**Elan-Santa Monica Place Senior Assisted Living/Memory Care  
6901 San Vicente Ave. NE  
Request Permanent C.O. - Accepted  
Engineer's Stamp dated: 10-16-15 (D18D054B)  
Certification dated: 2-10-17**

## DRAINAGE AND TRANSPORTATION INFORMATION SHEET (REV 09/2015)

**RE: Santa Monica Place (Senior Assisted Living/Memory Care)  
East End of Tract 3  
Grading and Drainage Plan  
Engineer's Stamp Date 10-16-2015 (File: D18D054B)**

## CONCEPTUAL GRADING & DRAINAGE PLAN

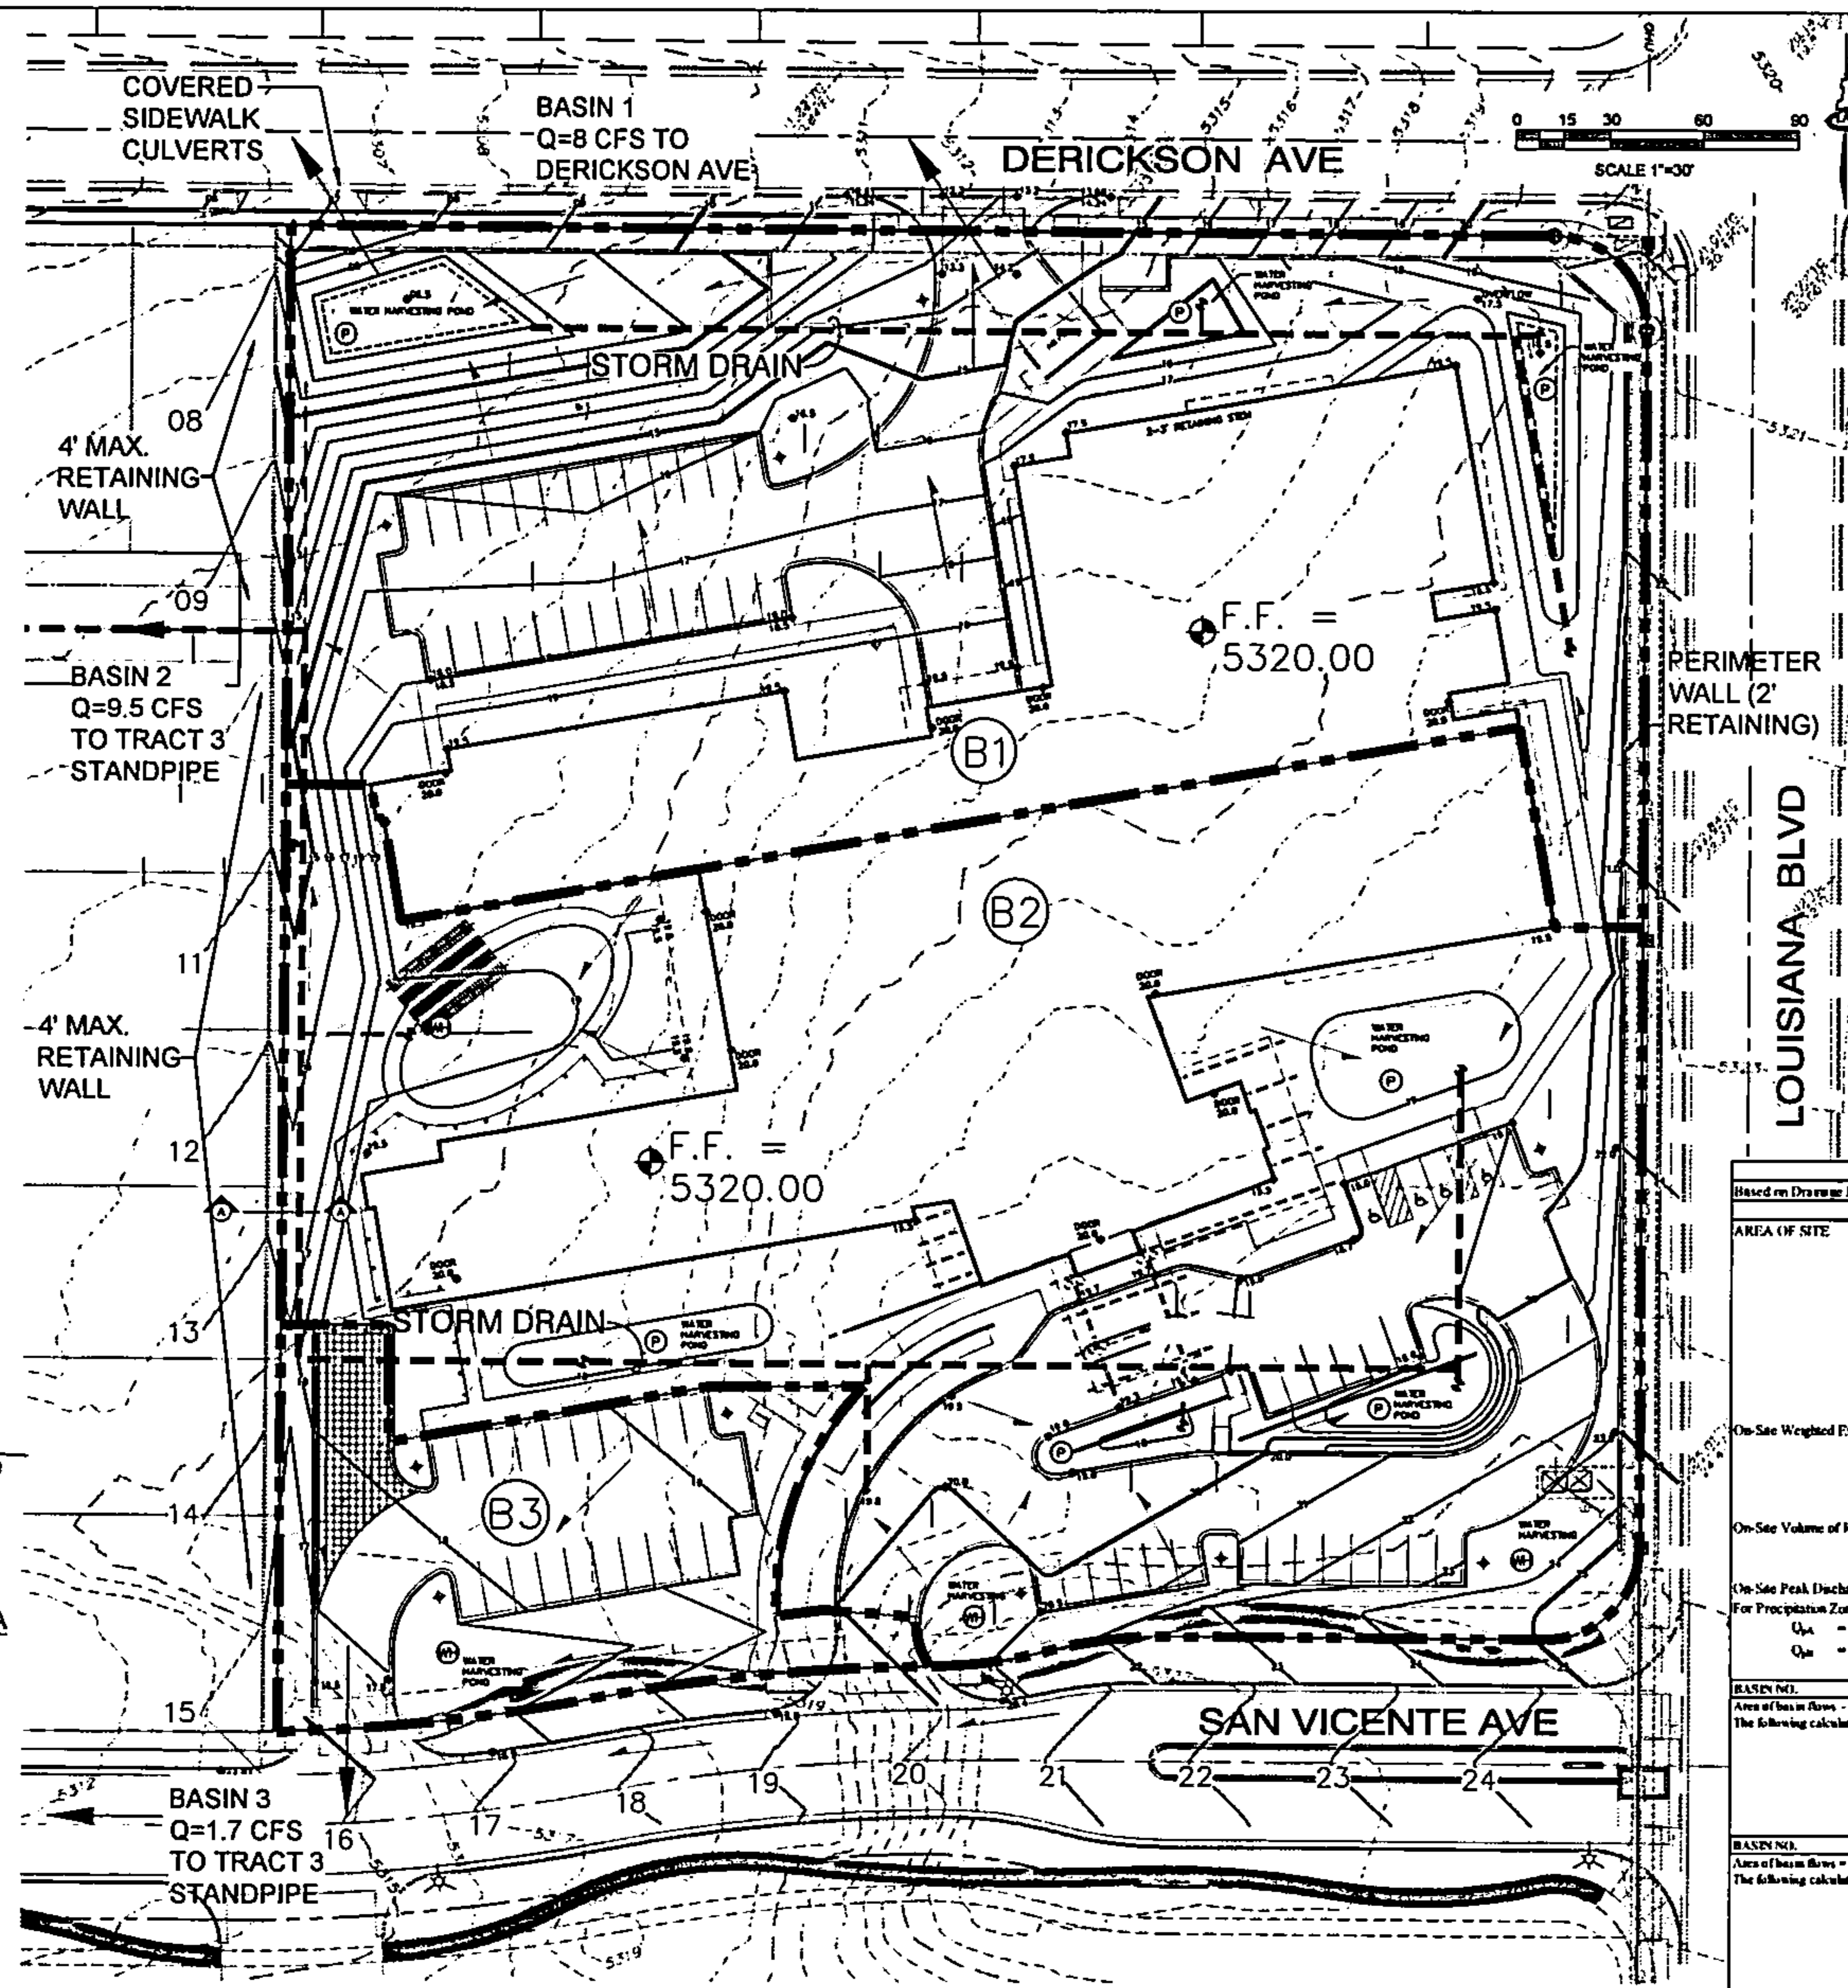
1. Previously, you had received Hydrology comments for EPC regarding this site. The comments were to manage the first flush and provide calculations on a revised Conceptual Grading and Drainage Plan. The purpose of this comment was to make sure you had sufficient room with the proposed layout for the water harvesting. Although conceptual water harvesting ponds are shown, no calculations were provided with the resubmittal. Please provide them with the next submittal.

Although Tracts 1 through 4 have a cross-lot drainage easement from the Bulk Land Plat, provide a low erosive interim solution such as rip-rap for drainage from the proposed Tract 3B to the existing standpipe in the current Tract 3.

4. The AHYMO run shows Basin 1 as 7.8 cfs, Basin 2 as 9.3 cfs, and Basin 3 as 1.6 cfs. However, the flows under the basin descriptions in the grading part of the plan are different and total more than 18.8 cfs. Revise the descriptions to reflect the correct flows.
5. How much flow is coming from the offsite basin for Tract 4? How are you addressing those historical flows on your site until Tract 4 and San Vicente Avenue is developed?

Clearly show how getting Basins 2+3 flows to standpipe

so  $4.6 \times 3.98 = 18.25 \text{ cfs exist}$

Historical discharge Pop Basin  $2+3 = 9.3 + 1.6 = 10.9 \text{ cfs}$  18.25 exist
